Access Compliance Report

Public Rights-of-Way

(Curb Ramps)

Intersection ID: 46304	Main Street: AUGUSTINE_WY	Cross Street: MERMANS_RD	Location: SE
ADA ID: 5F30F088CE27	Ramp Type: Perp	Initial Pass/Fail: Fail	Overall Compliance: No
Severity Score: 22.5			
Codes/Mitigation Info/Possible Solution		Field Measurements/Component Compliance

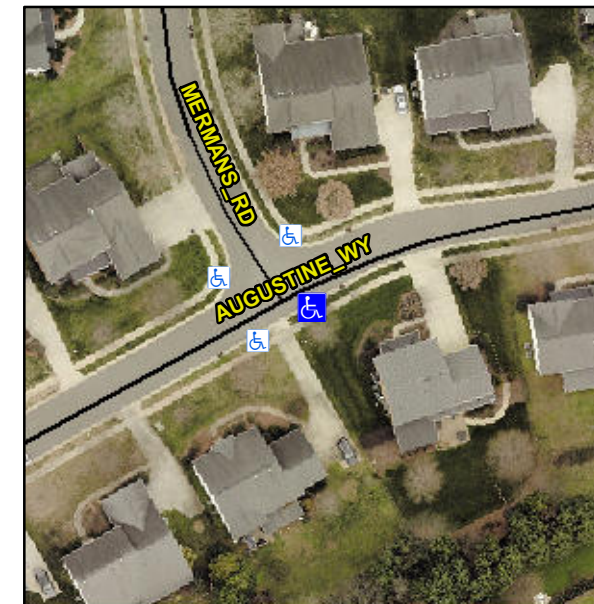
Not Found, R304.5.1, R304.2.2, R304.5.3

Compliance	Description	Data	Compliance	Description	Data
N/A	Ramp Length (in)	48.0	No	Ramp Slope (%)	10.6
No	Ramp Width (in)	45.5	No	Ramp XSlope (%)	2.2
N/A	Flare Type LT	N/A	N/A	Flare Type RT	N/A
N/A	Flare Slope LT (%)	N/A	N/A	Flare Slope RT (%)	N/A
N/A	Flare Traversable LT?	N/A	N/A	Flare Traversable RT?	N/A
N/A	Landing Length (in)	N/A	N/A	DWS Provided?	N/A
N/A	Landing Width (in)	N/A	N/A	DWS Contrast?	N/A
N/A	Landing Slope (%)	N/A	N/A	DWS Length (in)	N/A
N/A	Landing X Slope (%)	N/A	N/A	DWS Full Width?	N/A
N/A	Landing Curb? (Y/N)	N/A	N/A	DWS Offset (in)	N/A
N/A	Shared Landing?	N/A			
N/A	Gutter Ponding?	N/A	N/A	Gutter Slope (%)	N/A
N/A	Gutter Lip Ht (in)	N/A	N/A	Gutter X Slope (%)	N/A
N/A	Painted X Walk1?	No	N/A	Painted X Walk2?	N/A
	X Walk 1 Direction	To N		X Walk 2 Direction	N/A
N/A	X Walk 1 Width (in)	N/A	N/A	X Walk 2 Width (in)	N/A
	X Walk 1 Slope (%)	2.6		X Walk 2 Slope (%)	N/A
	X Walk 1 X Slope (%)	2.0		X Walk 2 X Slope (%)	N/A

Remove & Replace Entire Ramp.
